NOTICE OF DECISION

DECISION OF THE PLANNING ADMINISTRATOR

SUBDIVISION / CLASS 1 ADJUSTMENT CASE NO.: SUB-ADJ19-02

REQUEST: A consolidated application for a proposed 34-lot subdivision (Wren Heights) that the division of approximately 8 acres into 34 lots ranging in size from approximately 5,251 square feet to approximately 22,034 square feet. The applicant is requesting an alternative street standard for Earhart Street S and Felton Street S; in addition, a Class 1 Adjustment to reduce the minimum lot depth for Lot 7 from 120 feet, as required for double frontage lots under SRC 511.010(a), Table 511-2, to approximately 106-feet.

F:\2015 Projects\15128 Salem Heights Subdivision\The CAD\Civil\Exhibits\15128_Tree Removal Plan.dwg 5/29/2019 11:09:09 AM

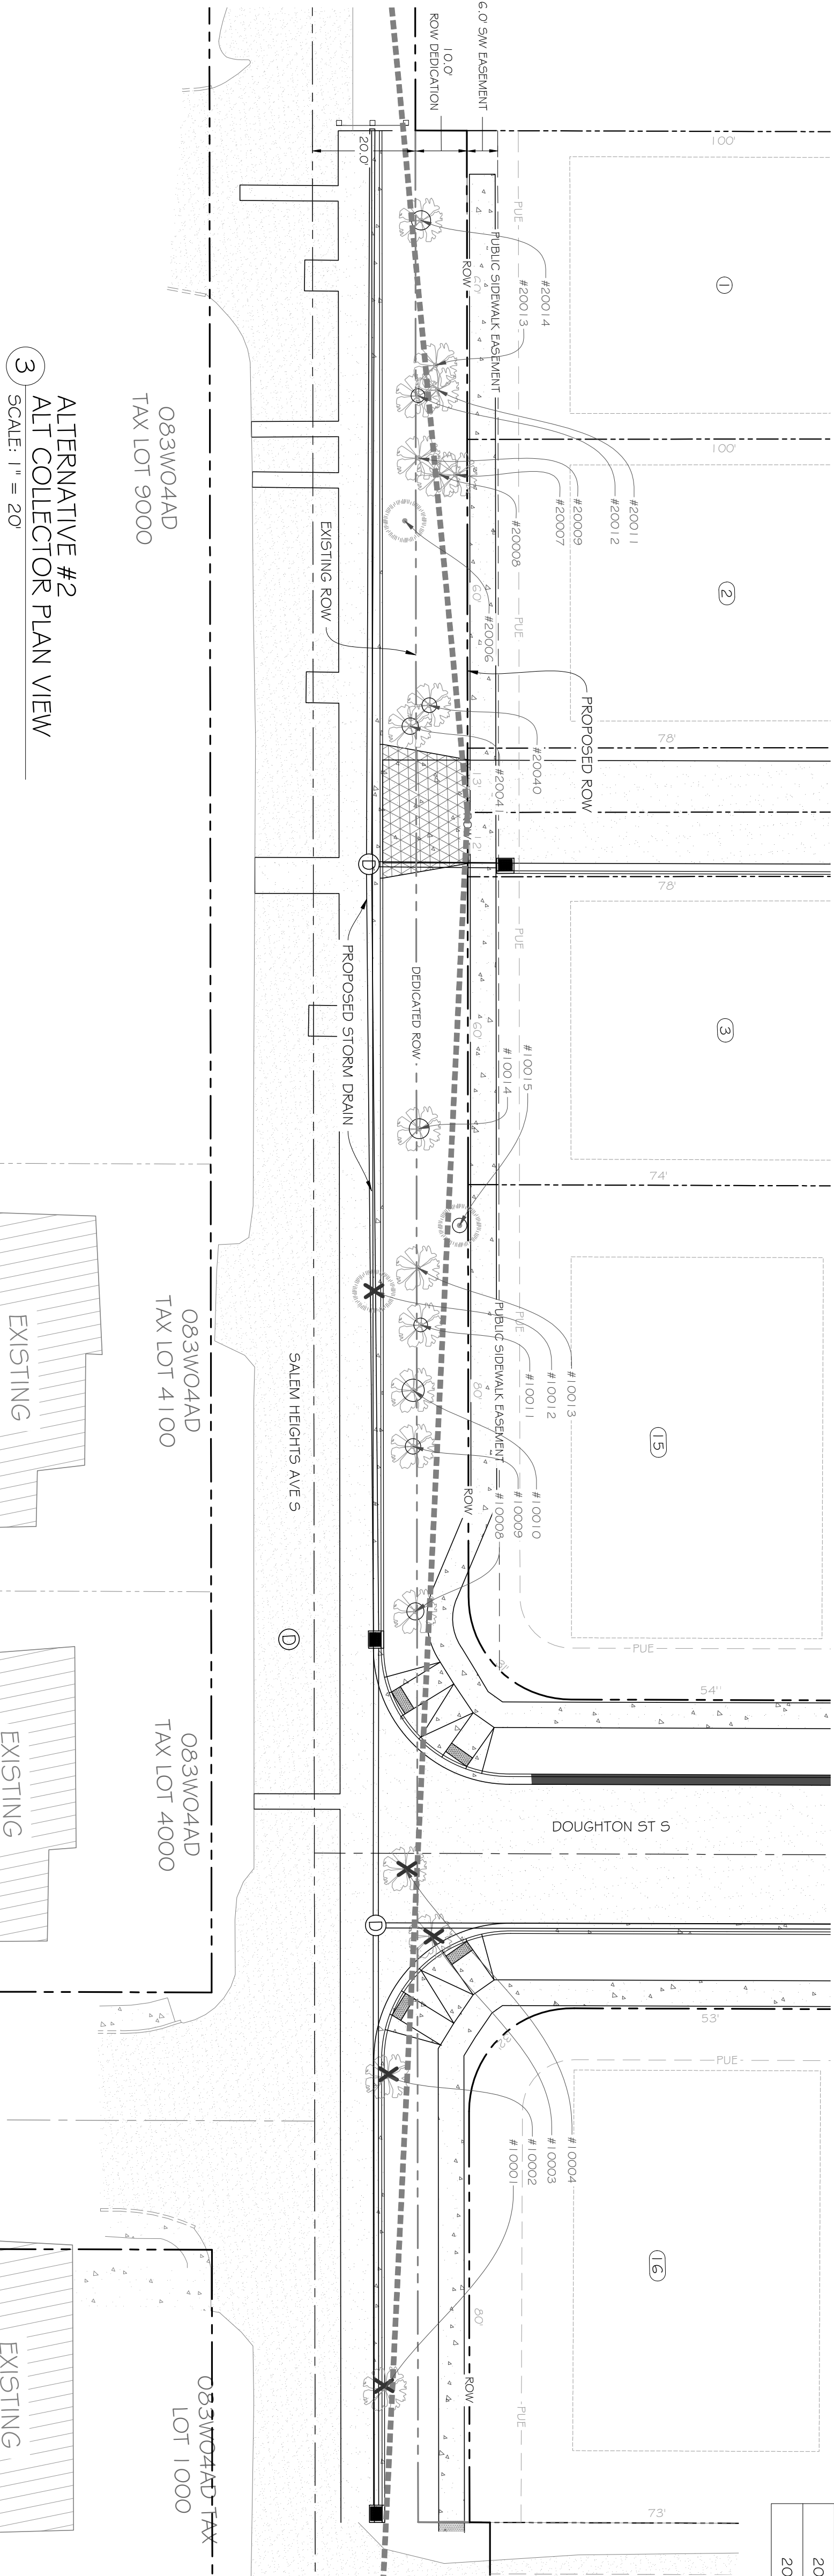
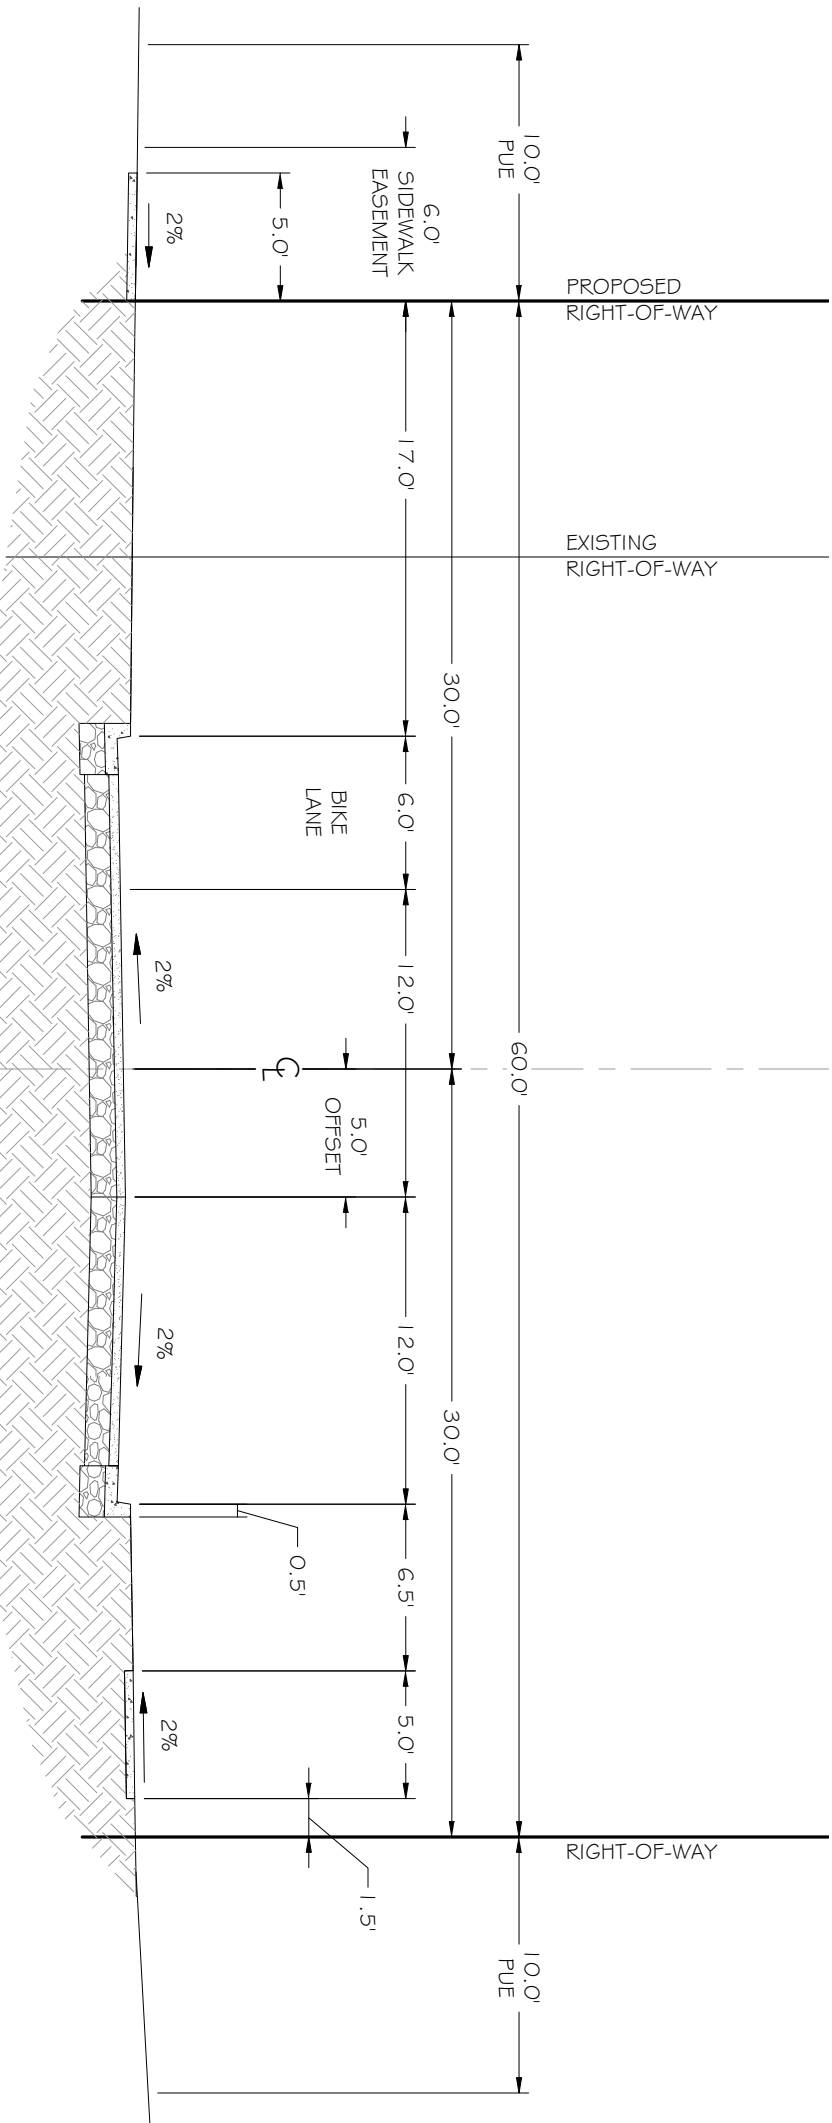
- Condition 8:** Prior to issuance of public construction permits, obtain final approval for tree removal permits for trees labeled as 10001 – 10004, and 10012 identified in the plan submitted on May 7, 2019 and titled Tree s within Right-of-Way Conservation Plan (Attachment C). Trees labeled as 10001 – 10004, and 10012 are tentatively approved for removal.

2. Prior to issuance of Public Construction permits, obtain tree removal permits for trees located within the right-of-way along the frontage of Salem Heights Avenue S. In accordance with the plan submitted on May 7, 2019 and titled Trees Within Right-of-Way Conservation Plan (C-1.17), trees labeled as 10001 – 10004, and 10012 are tentatively approved for removal. Any additional removal of street trees requires
